Executive Director's Recommendation

Commission Meeting: May 7, 2020

PROJECT Korean War Veterans Memorial Wall of Remembrance National Mall Daniel French Drive and Independence Avenue, NW Washington, DC	NCPC FILE NUMBER 8107
	NCPC MAP FILE NUMBER 1.71(73.10)45107
SUBMITTED BY United States Department of the Interior National Park Service	APPLICANT'S REQUEST Approval of preliminary and final site development plans
REVIEW AUTHORITY Commemorative Works per 40 U.S.C. § 8905	PROPOSED ACTION Approve preliminary and final site development plans
	ACTION ITEM TYPE Staff Presentation

Stormwater Drainage Areas

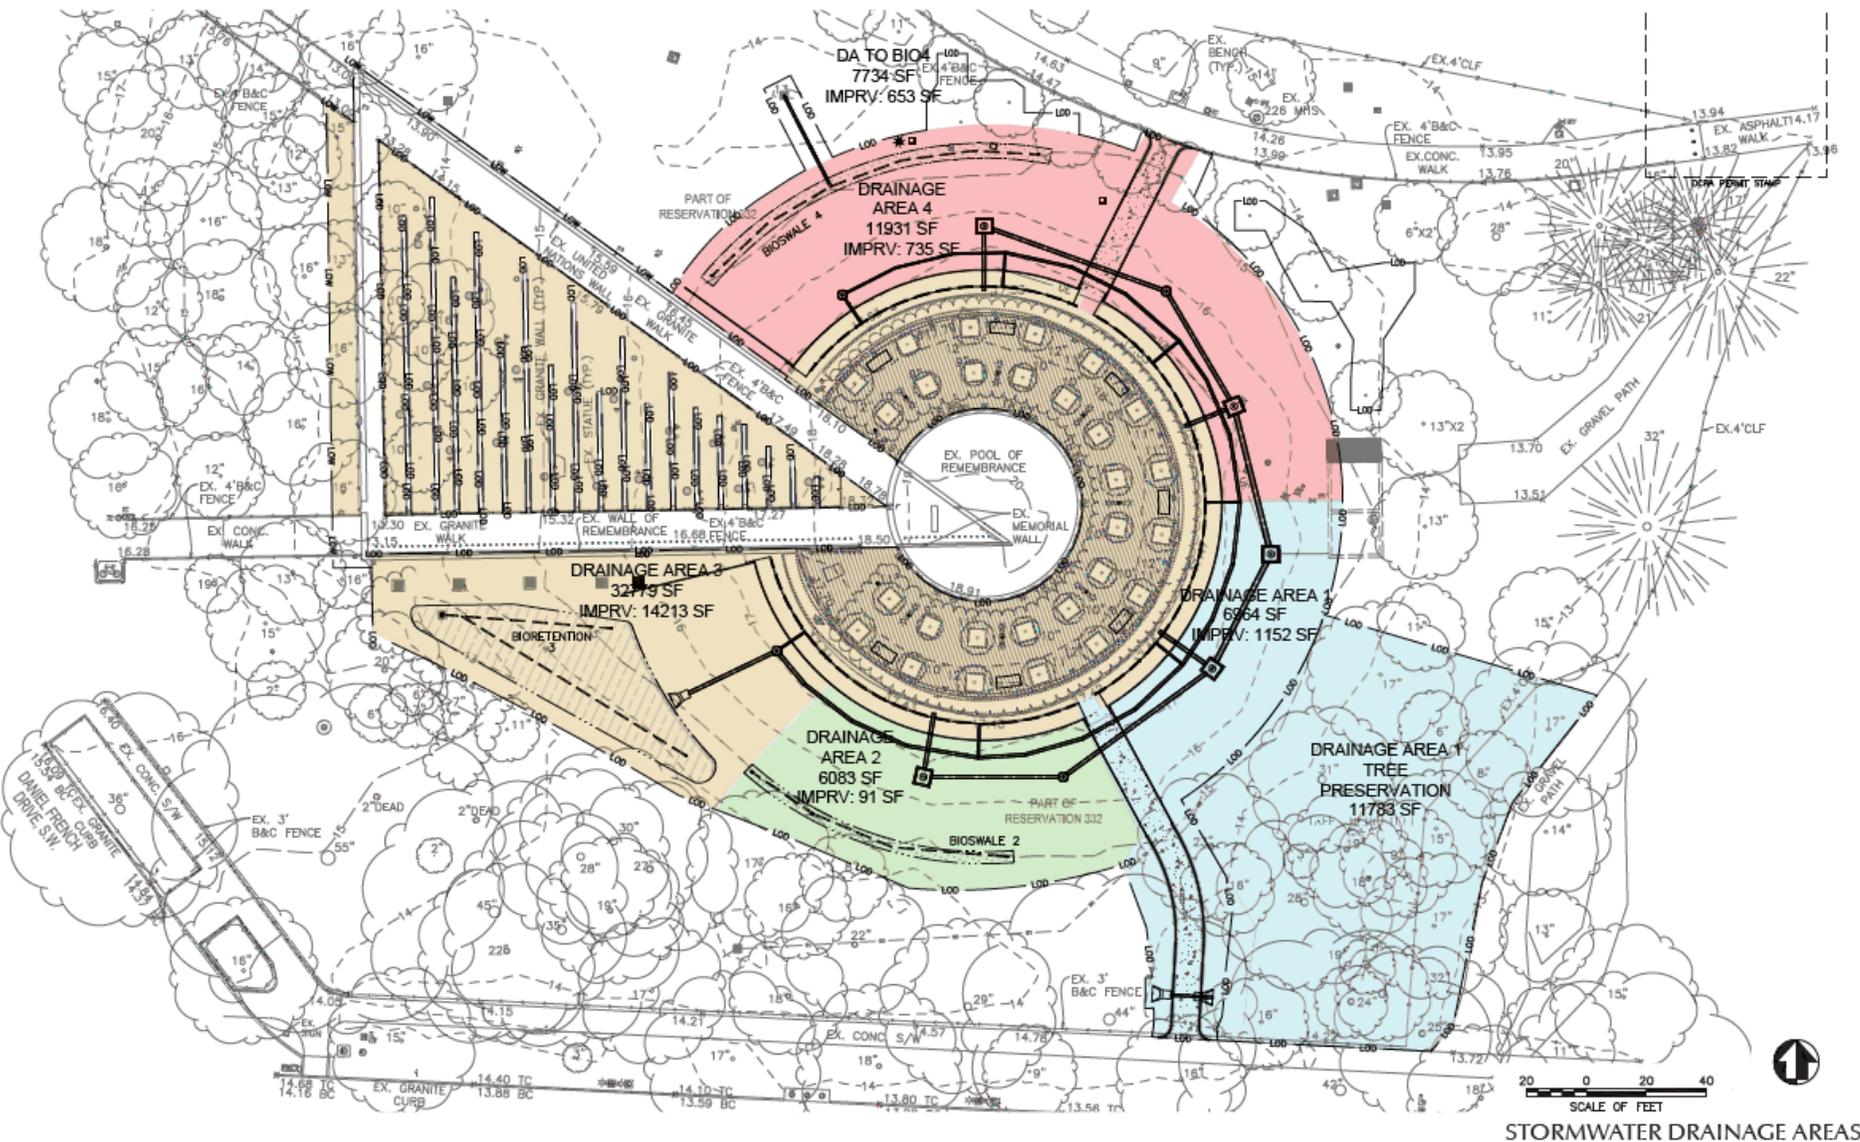
Stormwater runoff leaves the Memorial site at four different locations, forming four separate Drainage Areas (DA). Drainage Area #1 runoff sheets off into the stand of trees southeast of the Memorial. Drainage Area #2 drains to an existing grate inlet (1557) where runoff is conveyed towards Independence Avenue via 6" pipe. Portion of the existing subdrains under the existing pavers are conveyed to DA #2. Drainage Area #3 consist of a small area south of the Mural Wall that is captured by existing grate inlet 1314. Drainage Area #3 also includes flow from Field of Service and the entire plaza surrounding the Pool of Remembrance. Drainage Area #3 outfalls by way of an existing 15" RCP towards Daniel French Drive SW. Drainage Area #4 is made up of everything north of the Field of Service and the north half slopes surrounding the new Wall of Remembrance. A series of existing storm inlets and pipes ultimately converge at existing grate inlet 375 where runoff is directed north via a 12" pipe.

The estimated required SWRv for the entire site is 3,113 CF. At least 50% of the required stormwater retention volume (SRv) for each drainage area must be provided in each respective area or a DOEE waiver claiming "extraordinarily difficult site conditions" must be applied for. If the minimum of 50% of the required SWRv can be met, then off-site retention credits may be used to provide the Site's remaining required SWRv. Below is a summary of the SWRv requirements for each Drainage Area and the proposed facilities necessary for compliance.

• Drainage Area #1 will likely need a waiver as the existing grades sheet away from the Memorial with no existing low point in the proposed LOD to provide a traditional BMP and the ability to grade the area is constrained by existing trees. These constraints have been coordinated with DOEE and no treatment will be required in Drainage Area #1 so long as the required SWRv is captured by the other three drainage areas. Roughly 22 existing trees within DA#1 will reduce the retention volume required to be made up in the other three drainage areas

* REVISED PAGE *
 DETAIL DRAWING

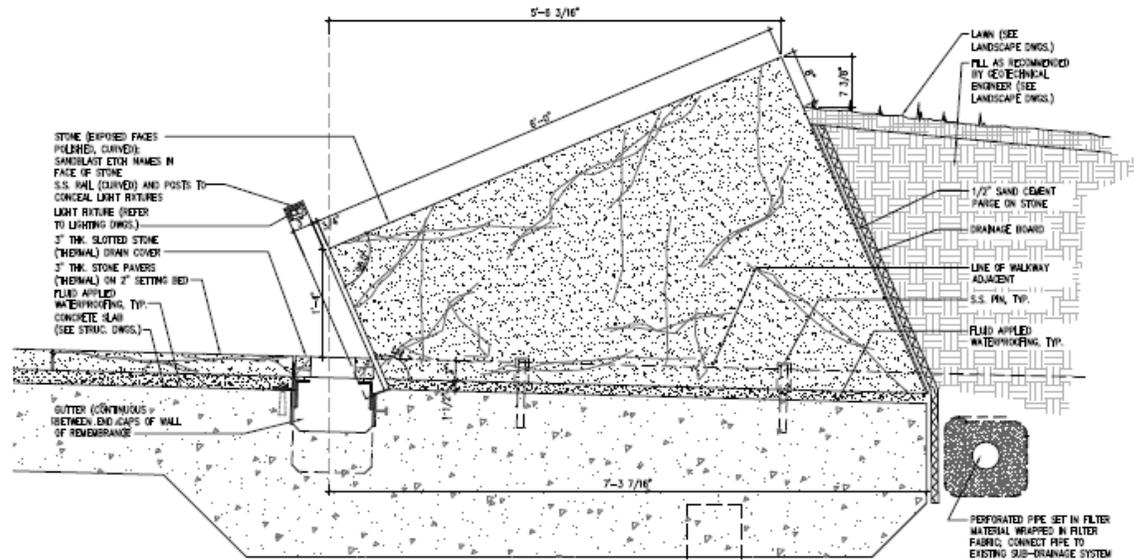
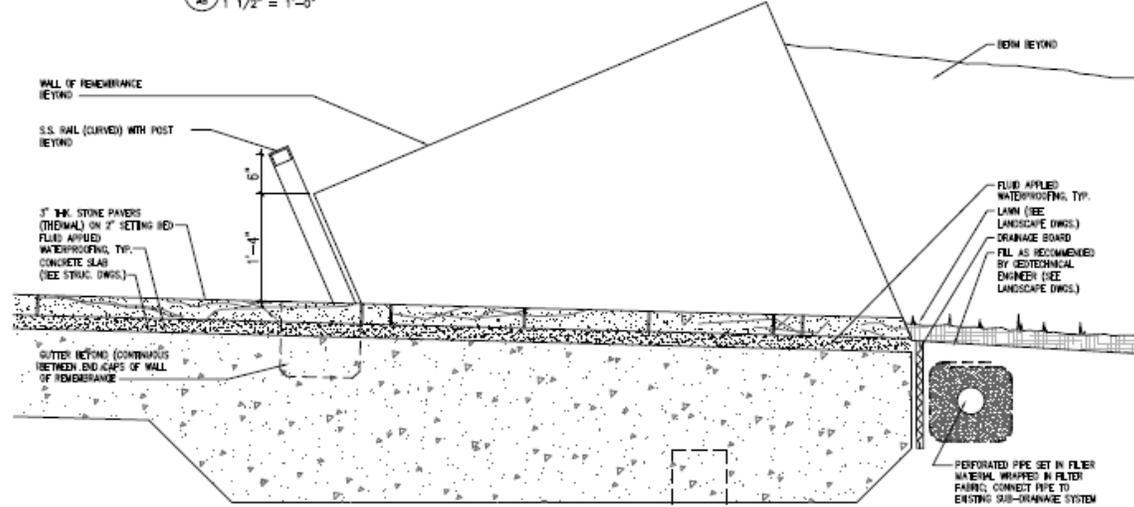
Finds that the wall profile has been simplified by eliminating the stone cap and lighting fixture on the top, and the slope of the wall has been modified, lowering the wall's overall height, while increasing visibility to and from the Memorial.

The proposed wall has a height of 3'8 ½" tall, reduced from the height of 3' 9 ¼" tall at the concept review. The wall will be approximately eight inches higher than the proposed berm. The wall includes a black granite frame around the perimeter. In response to comments under the concept review, the applicant has simplified the wall profile by removing the stone cap and lighting fixture at the top. In addition, the applicant modified the slope of the wall to lower the overall height and increase visibility to and from the memorial.

- Consider simplifying the wall profile to soften the transition into the landscape and maintain open views between the existing memorial components and the National Mall.
We have simplified the wall profile by removing the stone cap and lighting fixture at the top. In addition, we modified the slope of the wall to lower the overall height and increase visibility to and from the memorial.

MODIFY EXISTING UN CURB

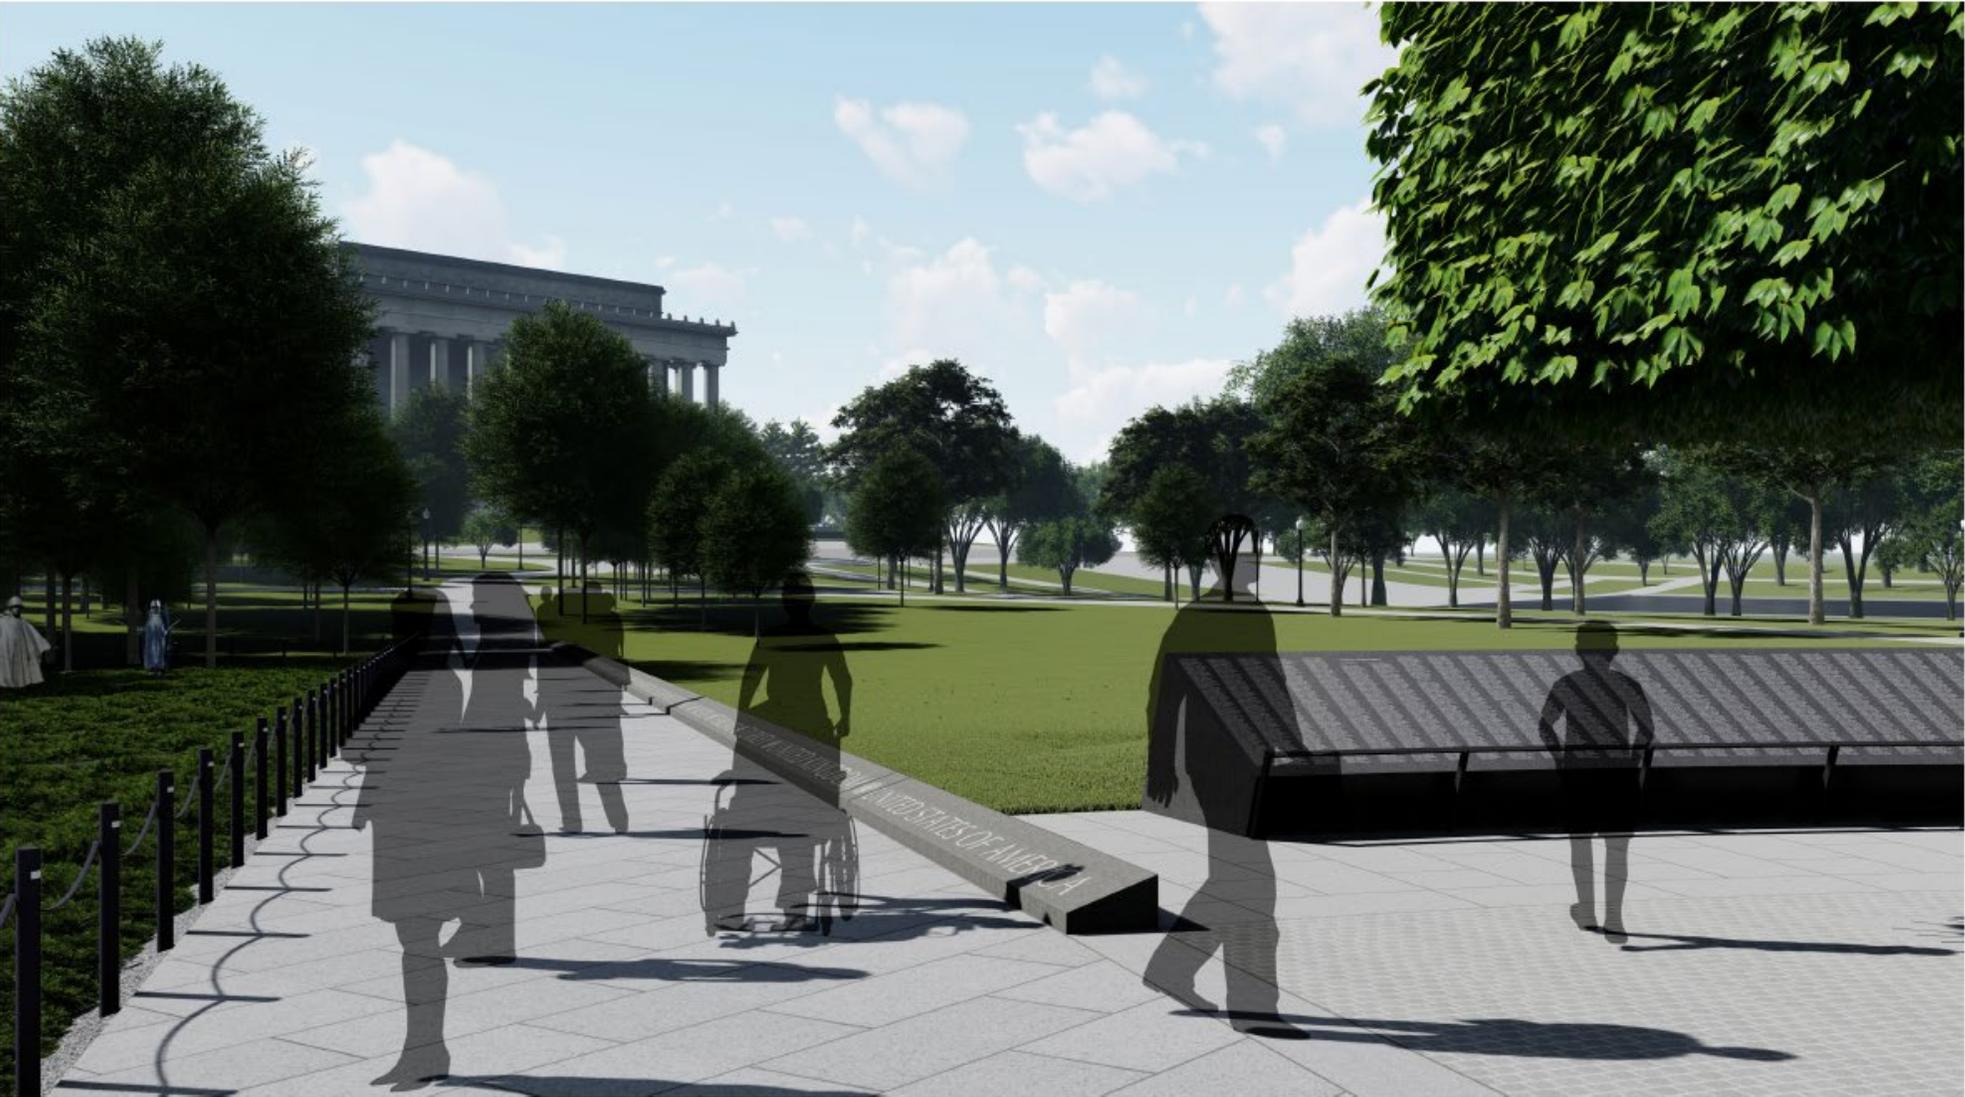
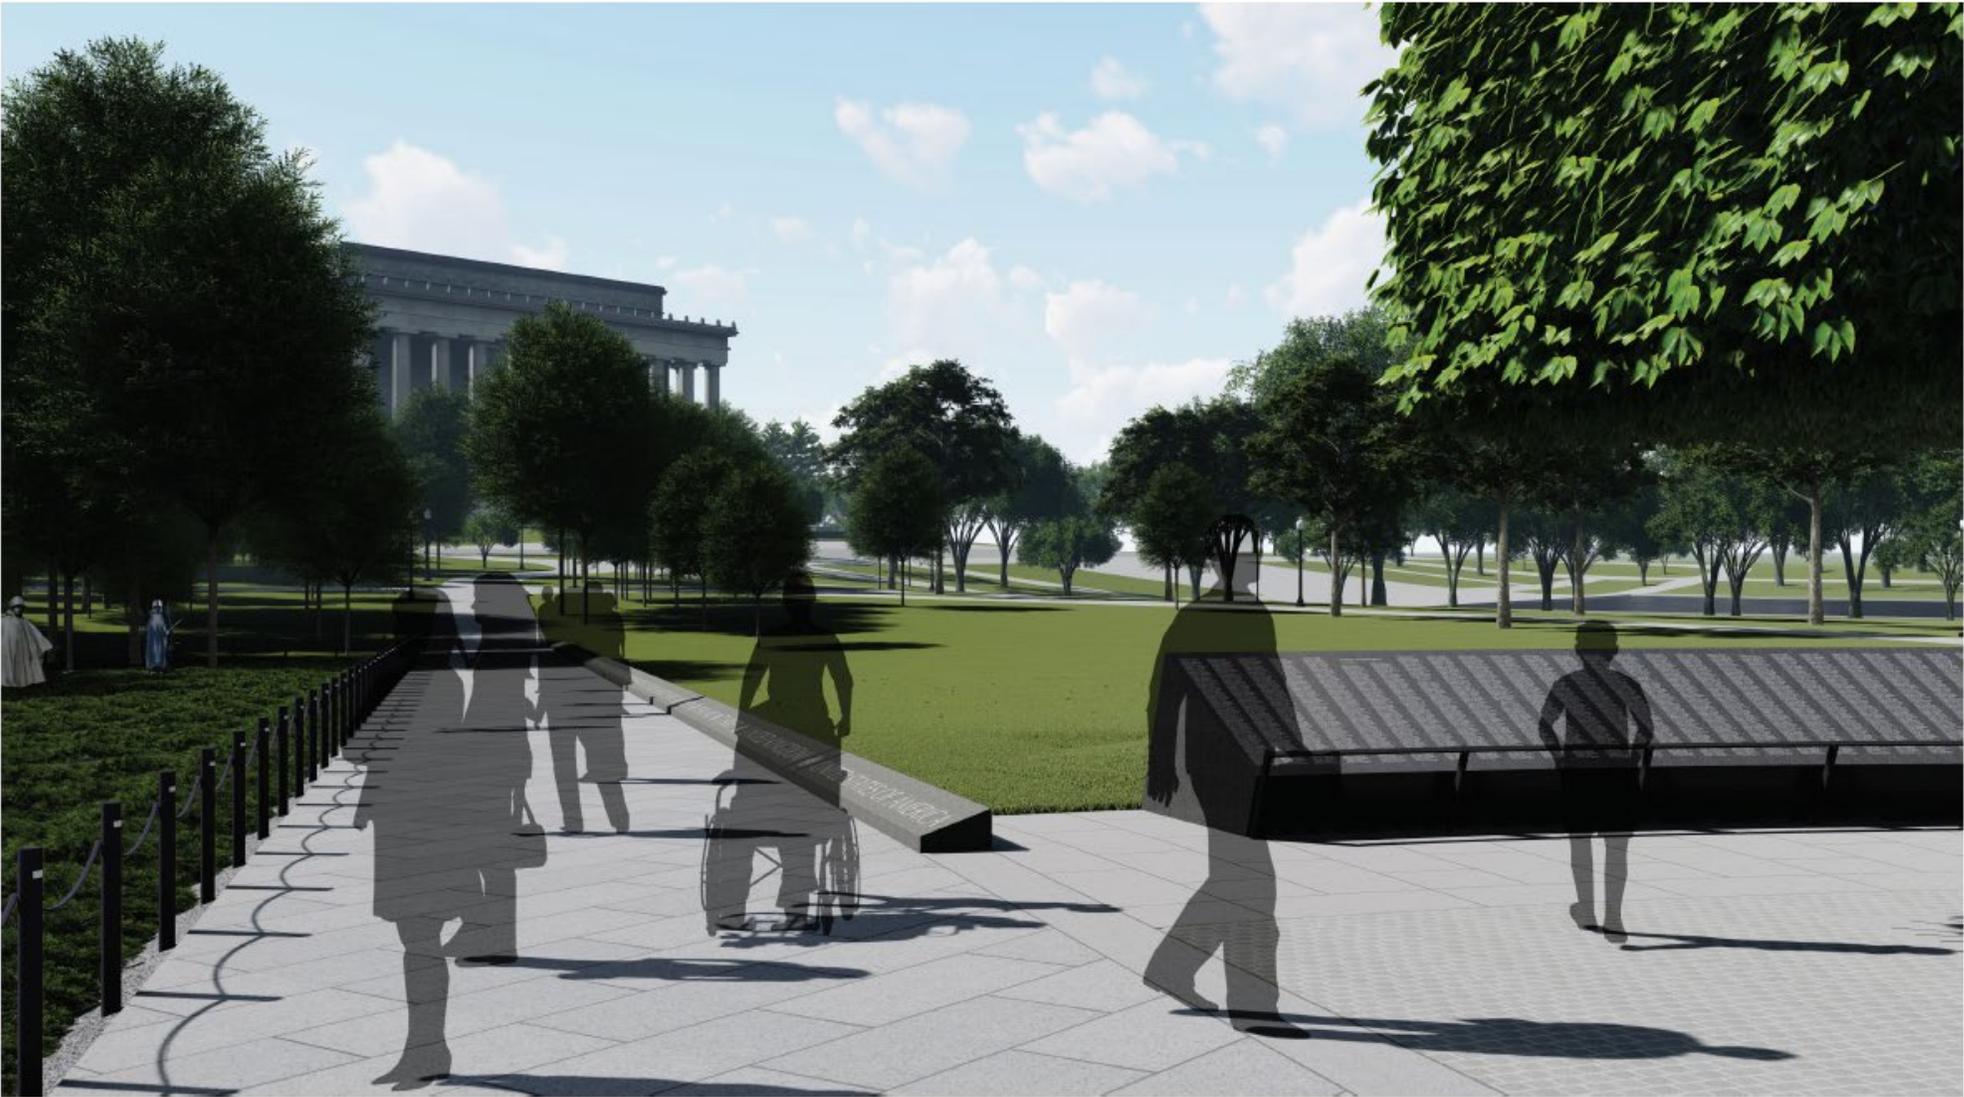
The existing memorial includes two low angled walls, including the 22 United Nations curbstone and the curb that defines an interior edge of the pool which lists the number of the casualties from the war. One minor modification to the existing memorial is proposed in the design. The existing UN Curb terminates on the east side at the edge of existing Plaza of Remembrance. Given that the paving is being extended out approximately 9 feet at the perimeter of the circular plaza, the existing curb would present a tripping hazard and circulation barrier if it were to remain. By shortening the overall length of the existing UN Curb by 5%, from 180 feet to 171 feet, the modified UN Curb

would align with the inside face of the Wall of Remembrance. In order to shorten the overall curb by 9 feet, the design proposes to decrease the individual country curb pieces and text to approximately 95% of the original length. The existing UN logo curb pieces that are between each country will not be modified given their square proportion. This does not conceptually change the existing memorial but rather modifies it in a discreet way in order to better incorporate the new Wall of Remembrance.

One minor modification to the existing memorial is proposed in the design. The existing UN Curb terminates on the east side at the edge of existing Plaza of Remembrance. Given that the paving is being extended out approximately 9 feet at the perimeter of the circular plaza, the existing curb would present a tripping hazard and circulation barrier if it were to remain. By shortening the overall length of the existing UN Curb by 5%, from 180 feet to 171 feet, the modified UN Curb would align with the inside face of the Wall of Remembrance. In order to shorten the overall curb by 9 feet, the design proposes to decrease the individual country curb pieces and text to approximately 95% of the original length. The existing UN logo curb pieces that are between each country will not be modified given their square proportion. We feel this does not conceptually change the existing memorial but rather modifies it in a discreet way in order to better incorporate the new Wall of Remembrance.

Lighting Mock-up of Previous Design

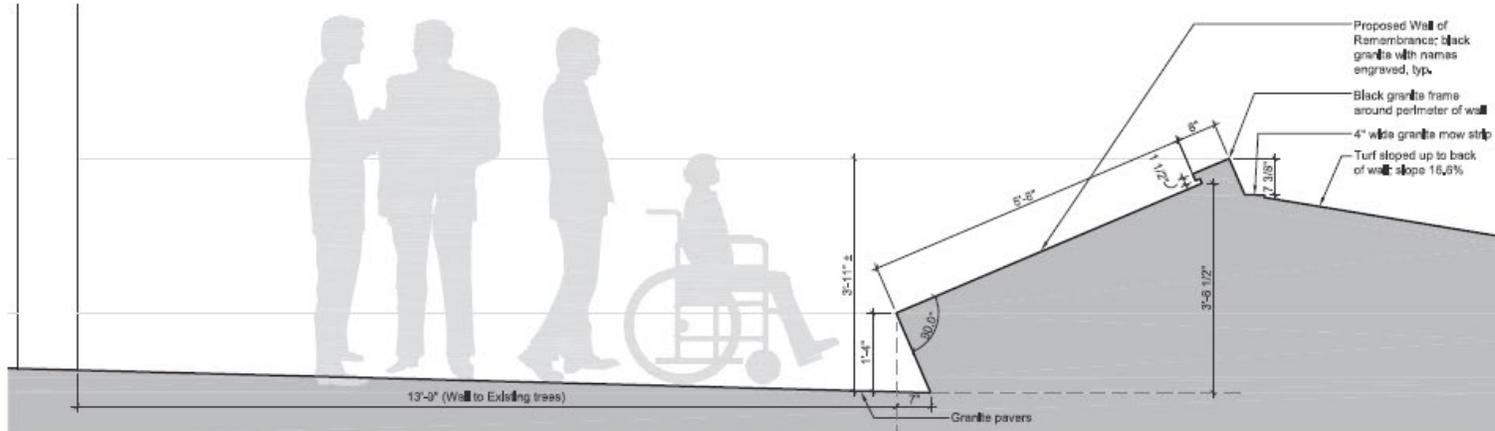
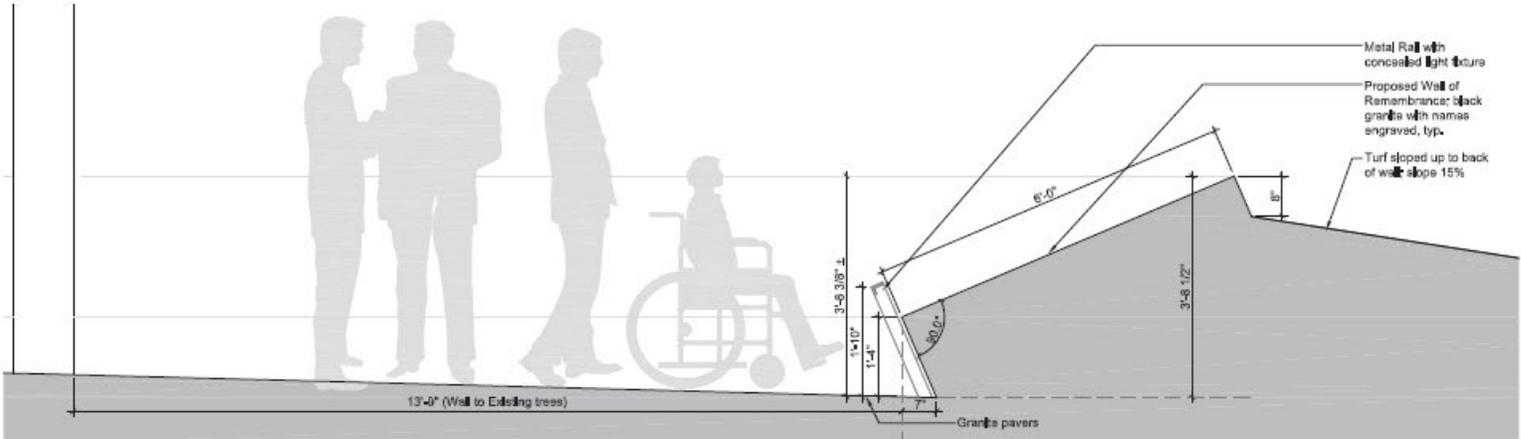
- Provide a mockup on-site of a segment of the proposed wall to evaluate how the reflective finish and angle impact glare and legibility, as well as visual impacts to the memorial and surrounding context.
A mock-up was provided on-site on March 2, 2020 and reviewed by members of NCPC, CFA, NPS, KWVMF and the design team. As a result of that mock-up, we confirmed that a polished finish was preferable and that the names were legible in all orientations. Additionally, a lighting mock-up was conducted later that evening where we determined that the original design concept of lighting the panels from a concealed fixture at the top of the panels was ineffective. There was glare from the light source at certain angles and the spread of light didn't transfer across the panels. Locating the light source horizontally at the lower end of the panels provided uniform light across the panels; this prompted the revision to the concept lighting design.

LED light strip at top beneath stone trim
- Visible hot spot
- Not enough light at bottom of wall

Overhead light source
- Light source visible
- Additional poles conflict with pedestrian circulation

LED light strip (vertical orientation) at bottom of wall
 - Visible hot spot
 - Uneven illumination at bottom of wall

LED light strip (horizontal orientation) at bottom of wall
 - No hot spot
 - Even illumination at top and bottom of wall
